# CITY OF ALBUQUERQUE

RE: **Lot 1 Block 11 Volcano Cliffs Unit 18 SAD 228  
6404 Petirrojo NW  
Grading and Drainage Plan  
Engineers Stamp Date 6/16/2020 (D10D003H1)  
Pad Certification Date 10/16/2020**

## DRAINAGE AND TRANSPORTATION INFORMATION SHEET (REV 6/2018)

ENGINEER'S SEAL	LOT 1 BK 11 U 18 VOLCANO CLIFFS SUB. 6604 PETIRROJO ROAD  GRADING AND DRAINAGE PLAN   <i>Rio Grande Engineering</i> 1608 CENTRAL AVENUE SE SUITE 201 ALBUQUERQUE, NM 87106 (505) 872-0899	DRAWN BY DEM
 6/15/20		DATE 6-15-20
		LOT 1 BK 11 U 18 VOLCANO CLIFFS SUB.
		SHEET # C1
DAVID SOULE P.E. #14522		JOB #  _____

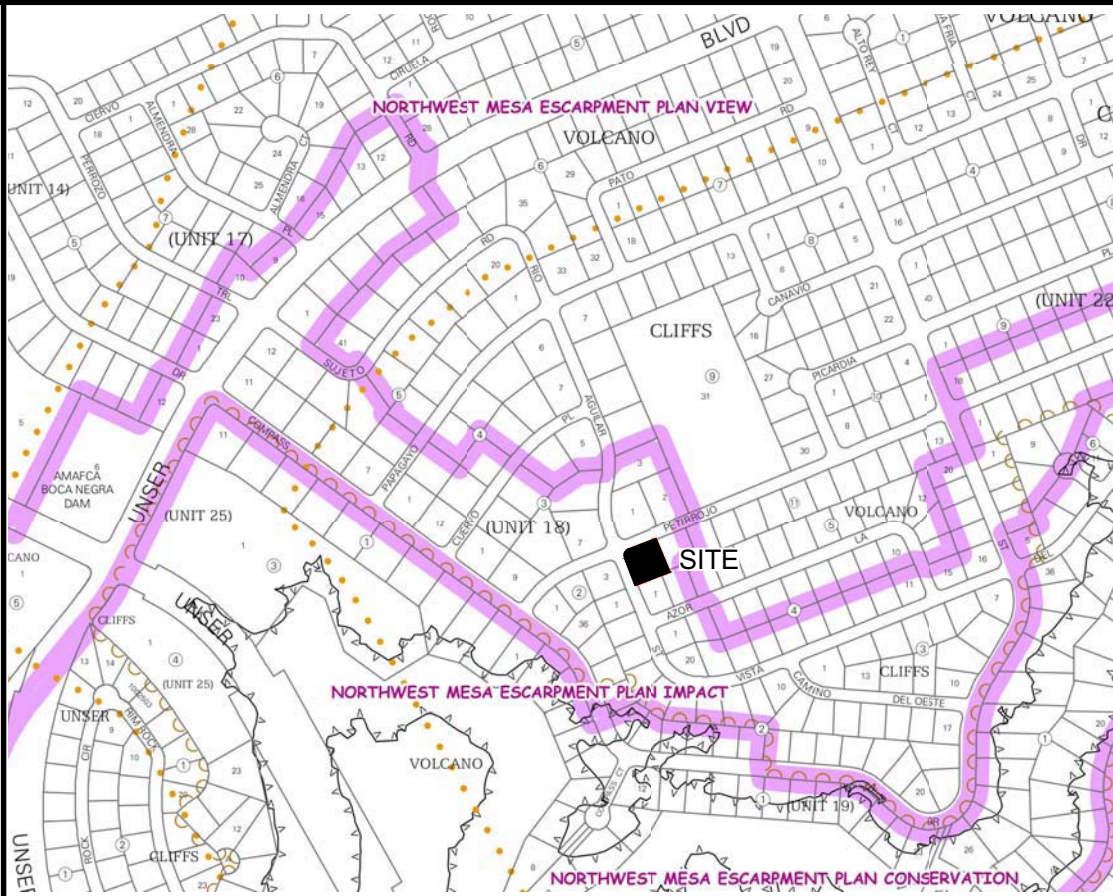
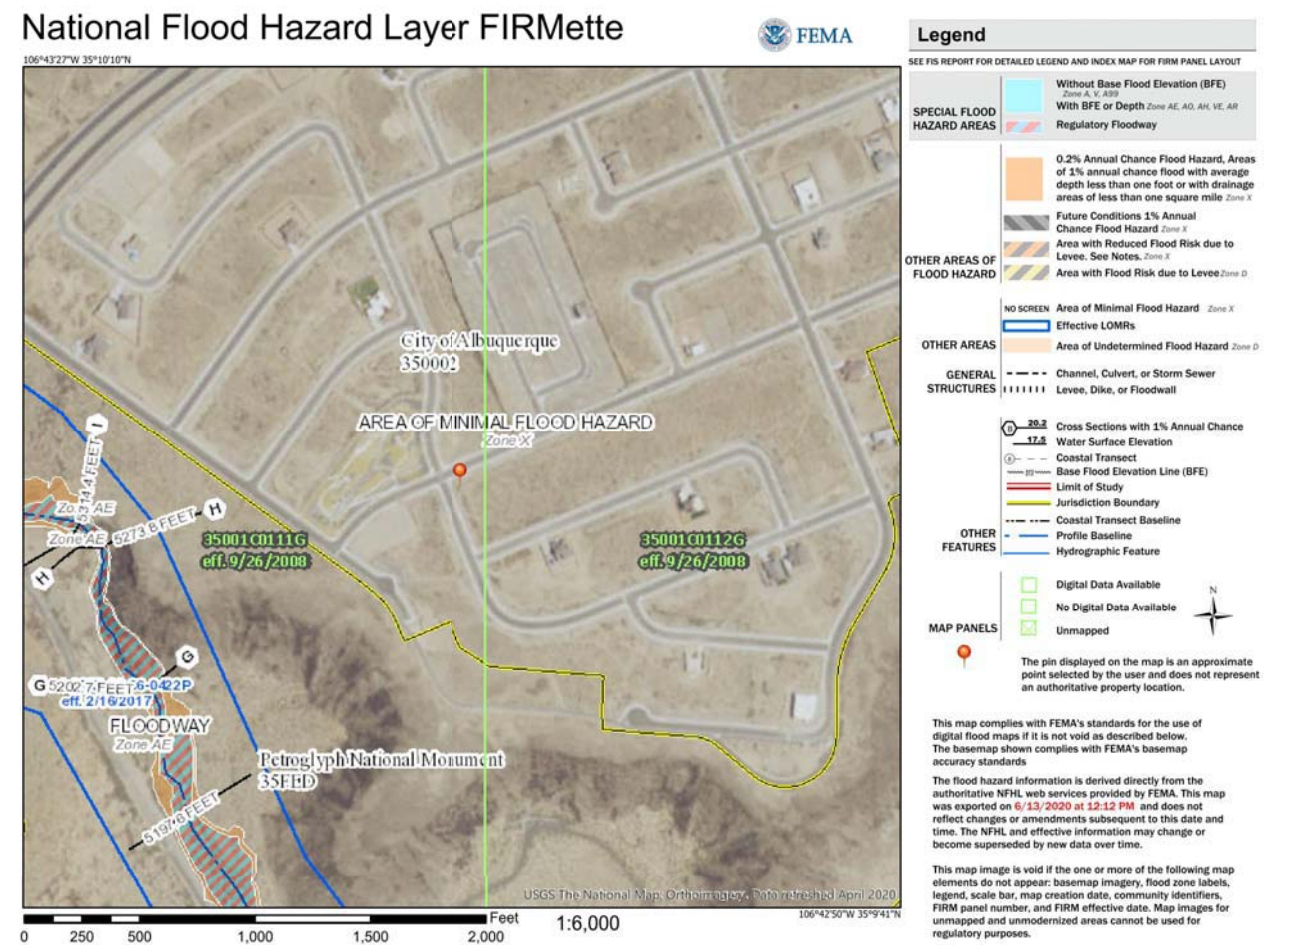
Based upon the information provided in your submittal received 10/20/2020, this plan is approved for Building Permit.

**Reiterate to the Owner/Contractor that a separate permit for a garden/retaining wall must be obtained, with the approved G&D plan dated and Pad Certification.**

Prior to Certificate of Occupancy release, Engineer Certification per the DPM checklist of this plan will be required.
